Response to City of Cambridge, Region of Waterloo and Grand River Conservation Authority Comments – iPort Cambridge

City of Cambridge Comments	
Comment – Development Planning	Response
<p>The lands west of Street A are currently not designated or zoned for the proposed use. If an application for an Official Plan Amendment and Zoning By-law Amendment for these lands is not submitted concurrently with the Draft Plan of Subdivision, the lands west of Street A cannot be considered as part of the Draft Plan of Subdivision application. Additionally, any reference to these lands as part of the application must be removed from all reports and these lands should be identified as 'Additional Lands Owned by Applicant' on the draft plan.</p>	<p>The lands west of Street A have been removed from the limits of the Draft Plan, save for Block 6 which is proposed as an Open Space Block, and Block 7, which contains the stormwater management facility. The lands outside of the Draft Plan that are owned by the applicant have been so identified.</p>

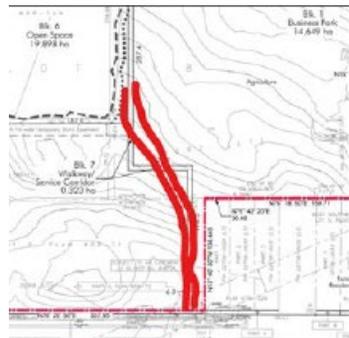
- Block 4 – A number of grades are obscured by other grades and an overland flow arrow.
 - a. Block 9 – The drainage/servicing easement provided for the future residential development to the west cannot be shown or provided at this time. Any servicing or easement will need to be determined at the site plan application stage. Please remove from all drawings.

- b. Block 9 – The grades at the west limits of the property (both areas) are lower than Intermarket Road. Please confirm how the block will drain to Intermarket Road.

- c. Please provide additional grades as it is necessary to fully outline how each block will drain to their respective outlets.
 - d. Please provide additional grades and a preliminary profile through the three cells of the wildlife corridor including anticipated detention storage depths, etc.

- Revised
- Revised
- No longer applicable
- Revised
- See PND-02
- Noted
- The sewer pipe has been designed for the 100-year controlled flow from the roofs and SWM corridor, therefore there is unlikely to be any overland flow up to the 100-year storm event
- Provided

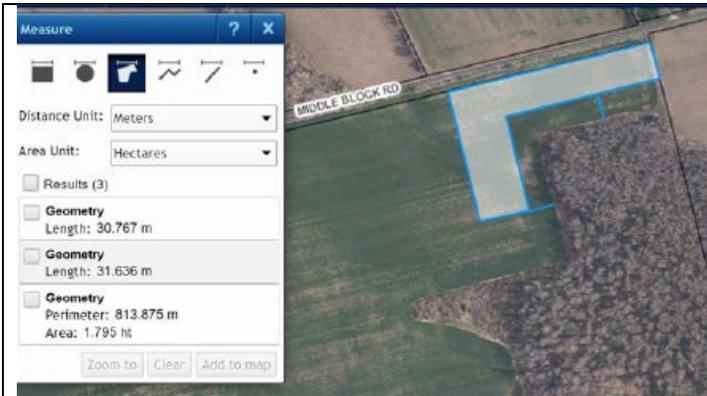
The block is "combined" with stormwater management and a "future stormwater management" notation on the Draft Plan. Combination of parkland blocks and stormwater management blocks is contrary to the Official Plan/parkland dedication policies. The City does not accept a park combined with a stormwater pond.

"Future Park" and "Open Space" need to be removed as references and the Block should be renamed "Block 5 – Stormwater Management"

Lands west of Intermarket Road have been removed from the Draft Plan, save for the Open Space Block and SWM Facility Block, both of which will be dedicated to the City. The Park Block is located in the northeastern portion of the site and is not combine with any other Block.

A markup of the Draft Plan is provided below with a summary of all of the above-noted required changes:

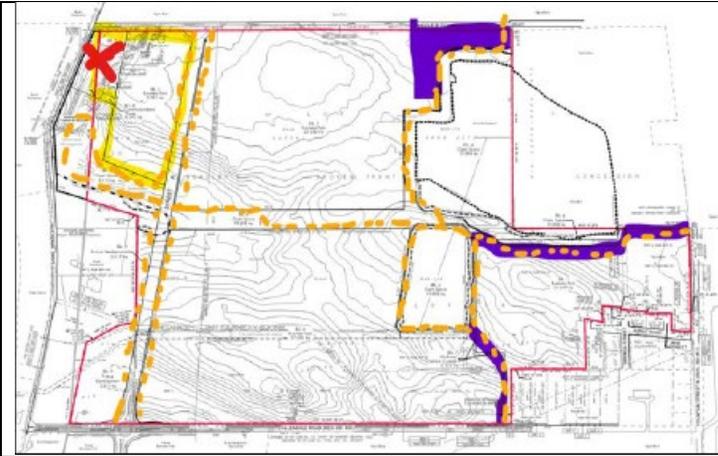
- Removing reference to "Future Park" from the SWM Block;
- Returning the "Future Park" lands to the adjacent block for development;
- Add a dashed line which depicts the active transportation network
- Add a Park Block abutting Middle Block Road
- Add a Trail Walkway Block connecting Fountain Street North to the trails system/OS Block (This is in a separate point below in Comment #3 as well); and
- Eliminate the 90 degree turns of the Block 7 Service/Walkway Corridor

- The Park has been relocated and identified as its own Block (Block 4)
- See above
- The identification of trails on a Draft Plan is not typical. Preference is to require the submission of a Trails Plan as a condition of Draft Plan approval
- Park Block 4 abuts Middle Block Road
- Walkway Block 9 provides a connection from Fountain Street to the future trails system
- The turns have been smoothed out within Block 8

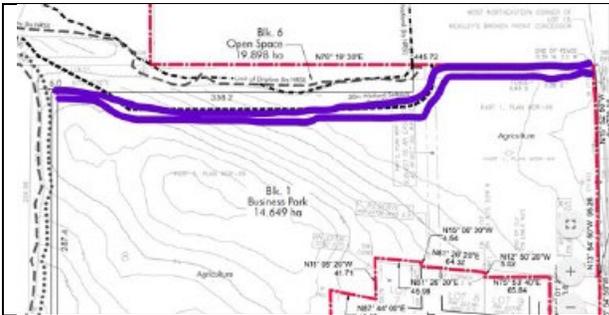
This photo below looks northward on Riverbank Drive where it meets Allendale Creek (blue-hashed colouring depicts location of creek). A SWM access north of here would complete the trail network as per OPA 35.

However, as can be seen in the photo the cross section of Riverbank Drive does not offer any room for continuing the trail neither as a bike lane nor Multi-Use Trail (MUT) and it is unknown (and unlikely) whether future road improvements to Riverbank Drive will provide an MUT. Furthermore, the slopes begin to increase as one travels northward on Riverbank Drive making an AODA-compliant trail expensive and/or not feasible. Dead ends in the trail network are acceptable if future plans provide some indication of potential continuation but that is not the case here. Finally, the Functional Servicing Study (SG-01, page 36 of 39, Site Grading Plan, see snip below) shows no SWM access to Riverbank Drive (see blue line/SWM access, green line is the MUT along the road as well as the road profile snip below and yellow line is the pedestrian walkway within the central OS corridor). The trail network should therefore be depicted on the Draft Plan (dashed line) to not have an outlet onto Riverbank Drive as per OPA 35 (and this is reflected in the proposed changes to the Draft Plan in Comment #2 above).

The lands west of Intermarket Road are located outside the limits of the Draft Plan, save for the Open Space Block and SWM Facility Block, both of which will be dedicated to the City.

The future Trails Plan will illustrate the location of all of the proposed trails within the limits of the Draft Plan. It is not typical to illustrate conceptual trails on a Draft Plan.
